Two independent hydrodynamic models show poor flushing, nutrient concentration and transport to phototrophic zones throughout the bay

FIGURE 1: BALD ROCK – Video of passive float release from 15 pens (Click left image to see play controls).

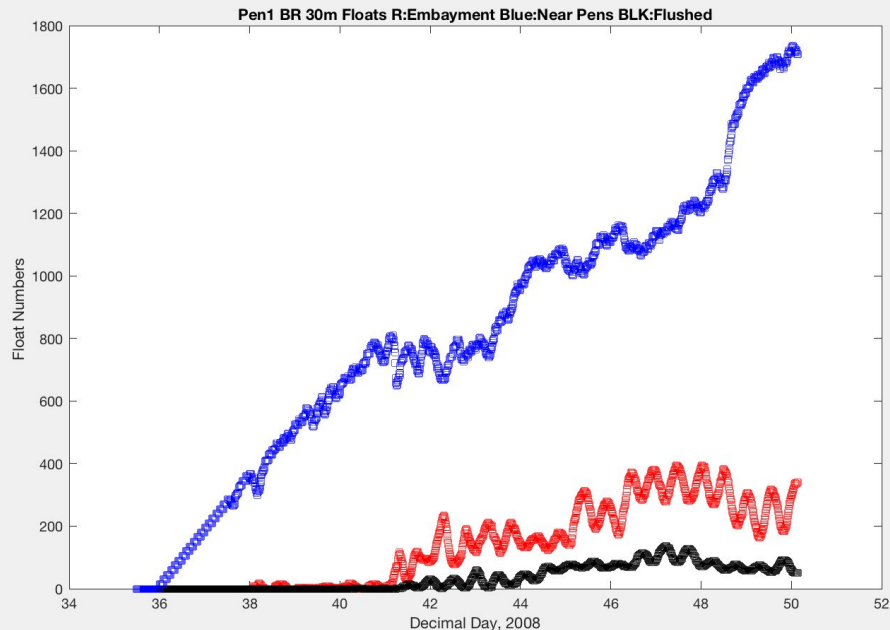
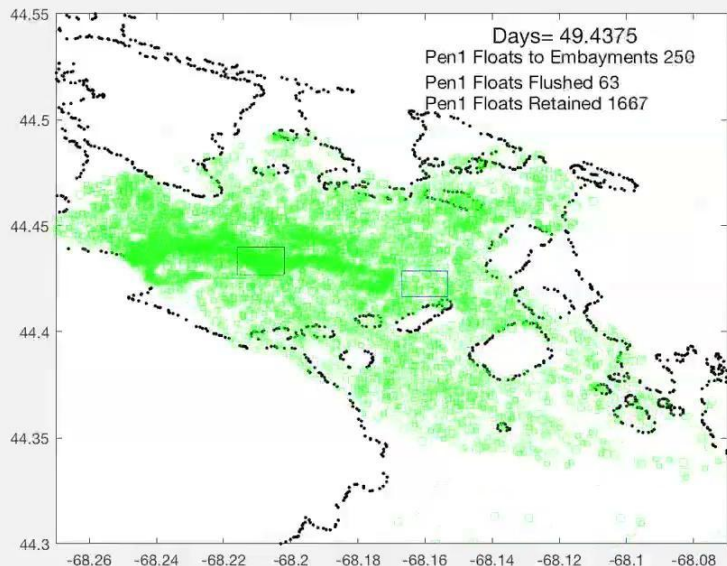
1. northward into shallower embayments,
2. southward, flushing from the system, or
3. in local, residual gyres that allow floats to be retained near the lease sites.

97% of floats (nutrients) are retained in the bay over the two week simulation run time.
Material will concentrate over time.

FIGURE 2: Long Porcupine – Video of passive float release from 15 pens (Click left image to see play controls).

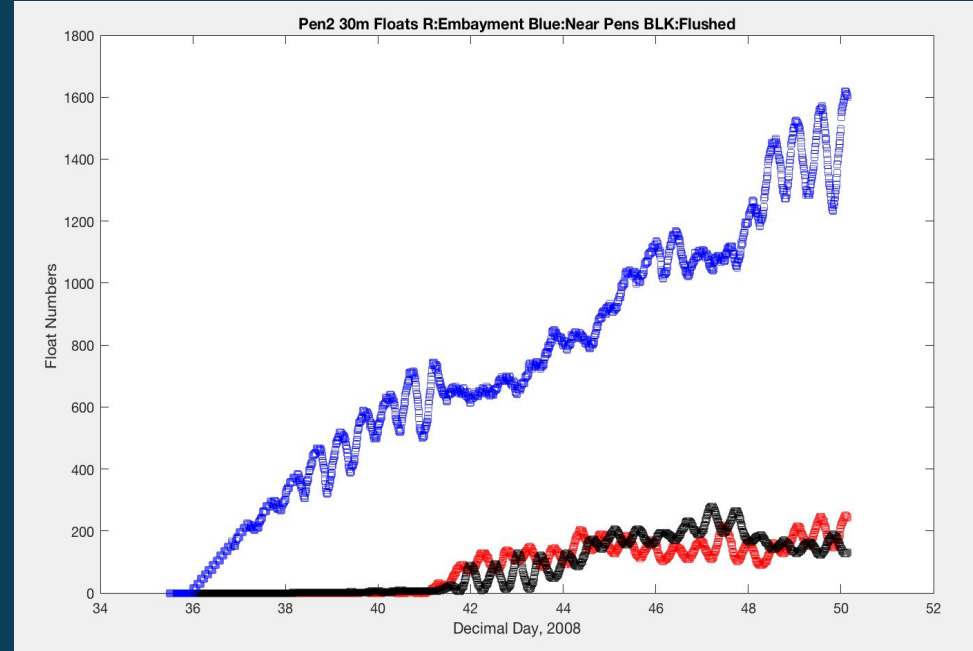
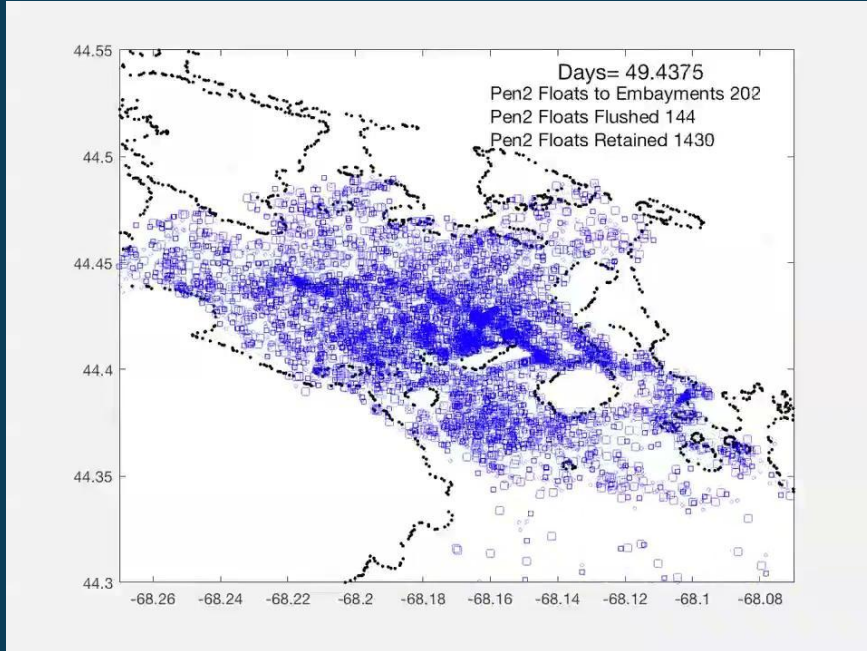
1. northward into shallower embayments,
2. southward, flushing from the system, or
3. in local, residual gyres that allow floats to be retained near the lease sites.

Movie of passive floats released from Long Porcupine.
90% of floats (nutrients) are retained in the bay over the two week simulation run time. Material will concentrate over time.

Count of discharged floats re-entering each lease site indicating concentration, not flushing.

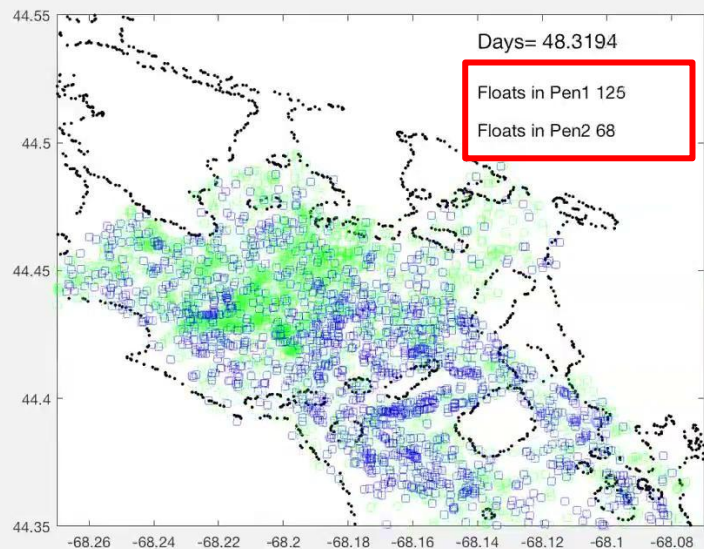
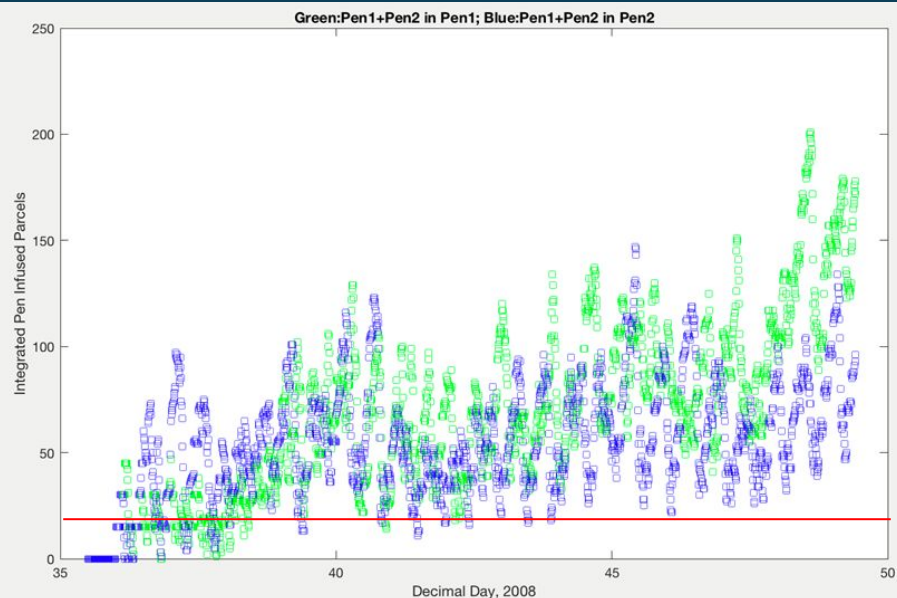
In the video on the left, floats track discharges from 15 pens released at 30m depths from both lease sites. The counts in the red box track the number of floats in the lease site at any given time. Anything above the 15 original discharges indicates that previously discharged parcels of water have re-entered the lease site raising nitrogen levels above baseline. Water travelling at this depth shows little evidence of mixing, so nitrogen injected into a parcel of water tends to stay with that parcel.

A background float number should be 15, if water is constantly swept away and not re-introduced to the Pen area. The color shows float numbers in each Pen, where floats could have been introduced from either Pen 1 or 2. **Below red line @15 means not concentrating.**
Green: Num Floats from Pen 1 + Pen 2 in Pen 1 Blue: Num Floats from Pen 1 + Pen 2 in Pen 2
